**From:** [Mark Chrisp](#)  
**To:** [Peter Skilton](#); [Hayley Thomas](#)  
**Cc:** [Samantha Lochery](#); [Suzanne O'Rourke](#); [Daniel Minhinnick](#); [Mark Apeldoorn](#); [Philip Comer](#); [timothy](#)  
**Subject:** External Sender: PC14 - Responses to Hearing Panel Directions  
**Date:** Friday, 21 March 2025 5:19:25 pm  
**Attachments:** [image001.png](#)  
[image002.png](#)  
[TM001-A2313738.00-Henmar Trust SW Response.pdf](#)  
[52332.12 PC14 Hearing Panel Direction No.2 - Economic Response.pdf](#)

### Structure Plan

The issue raised is the linkage from the northern collector road (as it passes through BIL's land) into the Henmar Trust land and whether there should be a roundabout at the intersection of those two roads.

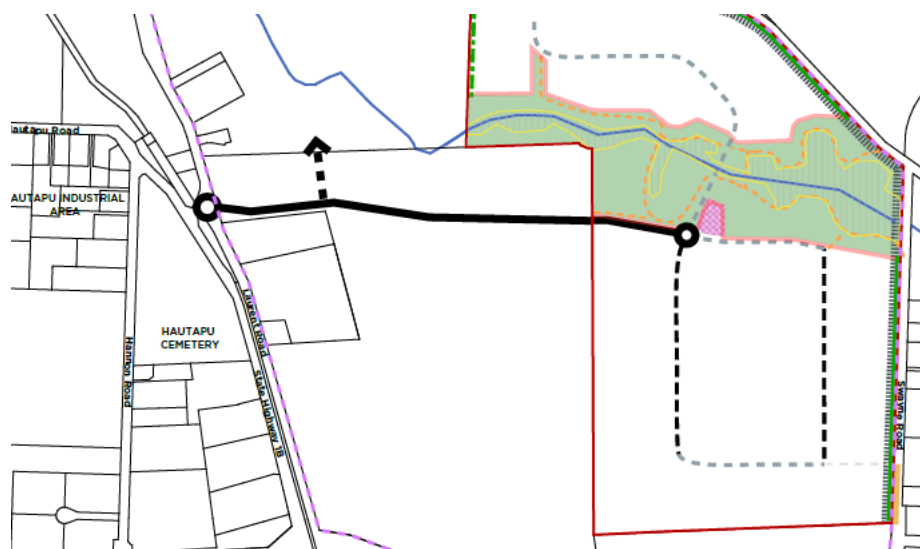
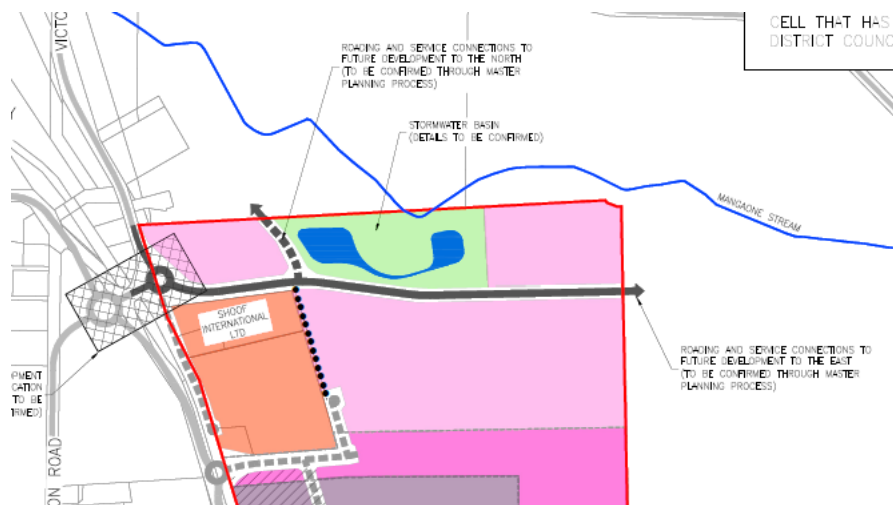
- *Initial BIL intentions indicated a collector road roundabout to manage a 4-leg intersection, and that is an appropriate safety response to the cross-road intersection*

- *Later C10 proposals intended the E-W Collector road, reflecting the need in the BIL structure plan, to accommodate all of the additional C10 land to the east, subject of this current proposal*

- *There is now no longer a requirement for a 4-leg cross road intersection. A standard T-intersection arrangement only is all that is likely to be required from a safety response perspective.*

- *A T-intersection readily accommodates the anticipated traffic demands (I've just run some scenarios to confirm this morning) with minimal queuing or delay*

- *A roundabout is proposed on Victoria/Zig Zag/Bruntwood, to address a 4-leg and identified adverse safety issue there*
- *A roundabout is proposed on C10/Zig Zag to respond to the high speed traffic environment there, not a factor in the C10 industrial internal roads (anticipated 50km/hr)*

- *Future demands on the Henmar Road link will be at levels commensurate with a*

Local Road and well below demand levels needed for a Collector Road.

- Notwithstanding the Henmar Local Road designation, the actual formation will be as required in the District Plan and appropriate for Industrial Subdivision servicing. So the road formation and carriageway dimensions will be appropriate to accommodate the vehicle types and demands. (Reference: District Plan, Appendix T4: Criteria for Public Roads). The road formation is the important part, not whether the status/hierarchy of the road is collector or local.

*In conclusion, a roundabout is not required for safety or capacity reasons. The link road traffic demands and its functional purpose are aligned with those necessary to support an Industrial Local Road function/purpose and demand expectations. They are inconsistent with a Collector Road function or demand level.”*

Our view is that the outcome should be as we have previously proposed. The following are the relevant Structure Plans (which are consistent in relation to the issue at hand):
